FINAL DRAINAGE REPORT

MAYBERRY, COLORADO SPRINGS – FILING NO. 3

**R&R JOB #MC22110
EPC PROJECT No. SF2219**

**ORIGINAL SUBMITTAL: MAY 2022
2ND SUBMITTAL: SEPTEMBER 2022**

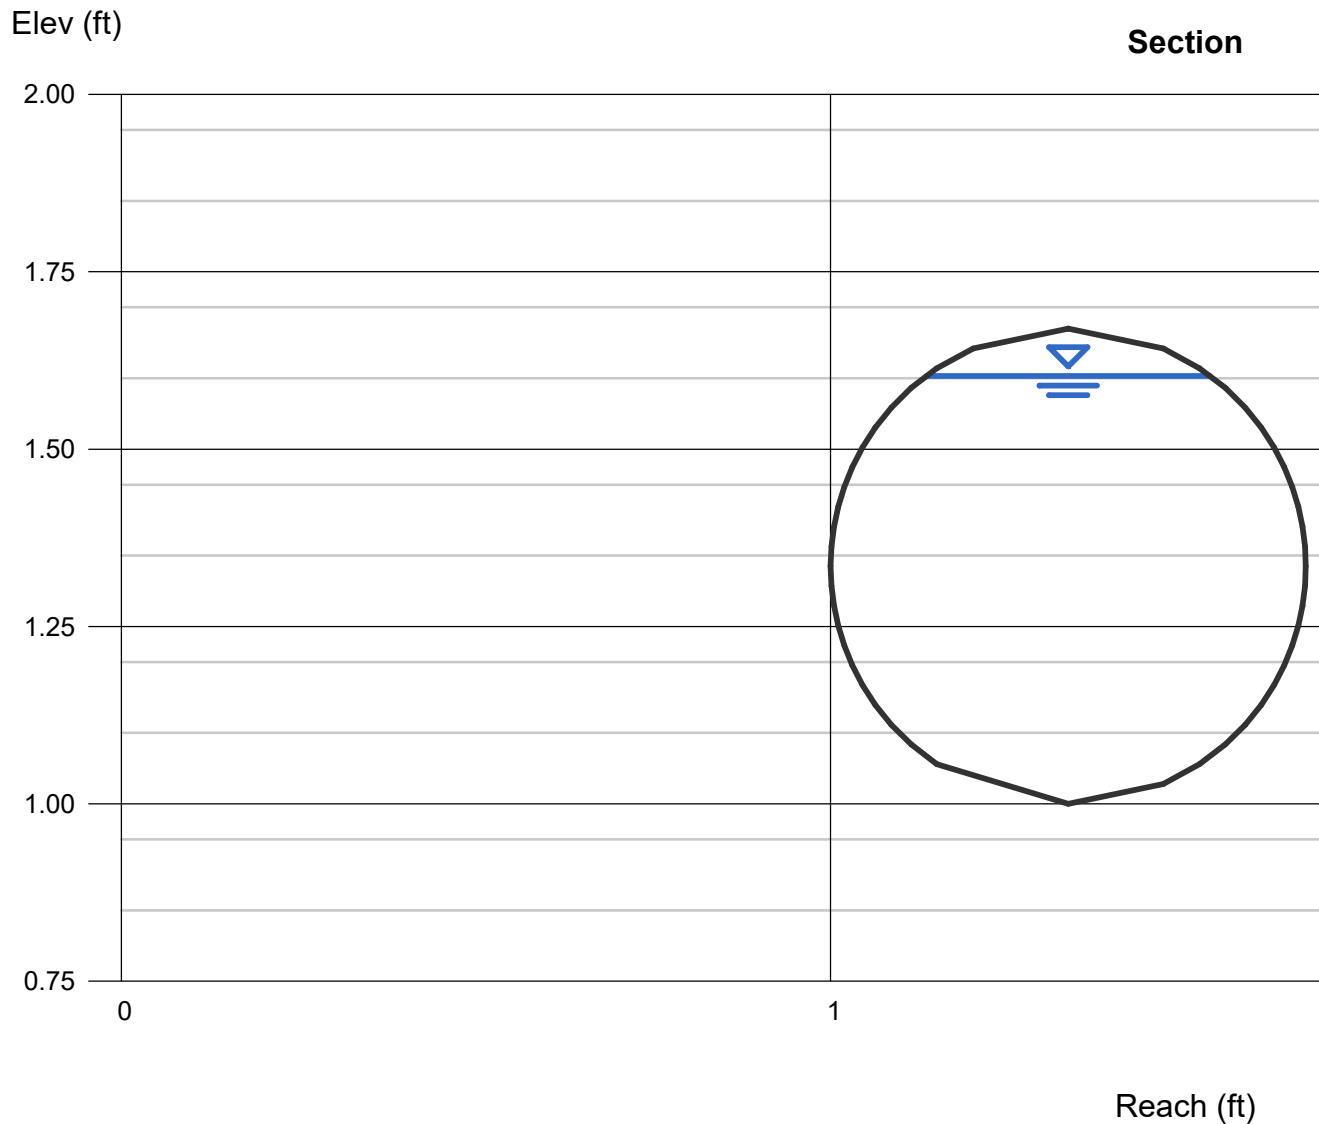
Please provide a schematic of the storm pipes. As the storm pipes/inlets are not labeled on the drainage plan it is difficult to discern where each of the storm pipes occur.

INLET IN A SUMP OR SAG LOCATION

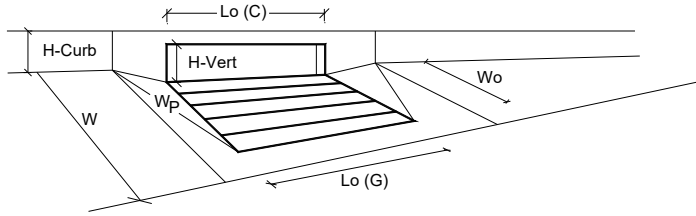
I ran the calculation using an older MHFD version and the latest 5.02 and it appears that a 15' inlet may work. Please verify/revise the calc. accordingly.

INLET IN A SUMP OR SAG LOCATION

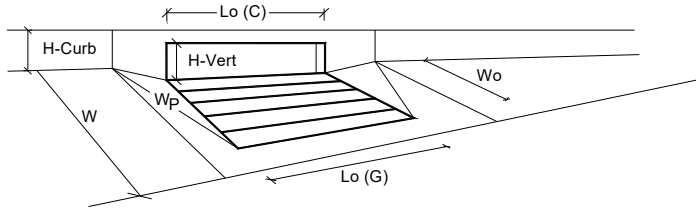
a 5' inlet is shown on the CD's and is drawn on the drainage plan. Revise.

INLET IN A SUMP OR SAG LOCATION

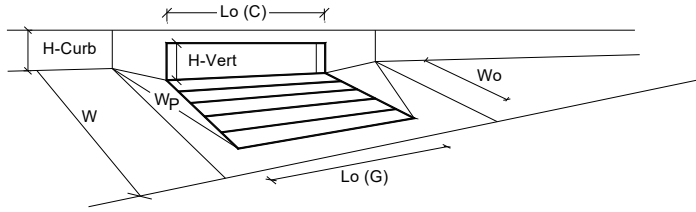
5' shown on the CD's and drainage plan. Revise

INLET IN A SUMP OR SAG LOCATION

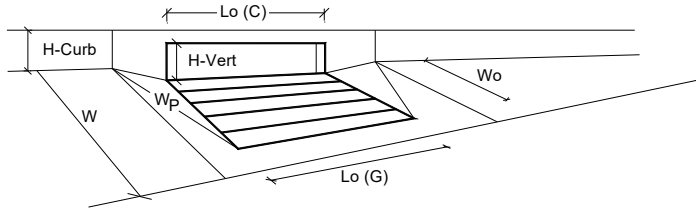
a 5' inlet is shown on the CD's. Revise the CD's accordingly so that they are consistent.

INLET ON A CONTINUOUS GRADE

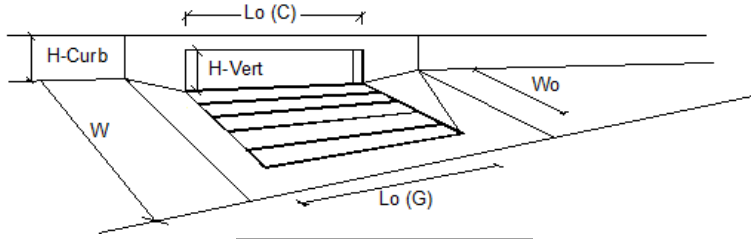
Please provide a capacity calculation for the roadway Galveston Terrace (60' ROW). This roadway is conveying the majority of the runoff from basin C2.3 to DP3 in Mayberry drive. Staff has concerns as to whether it has the capacity to convey these flows.
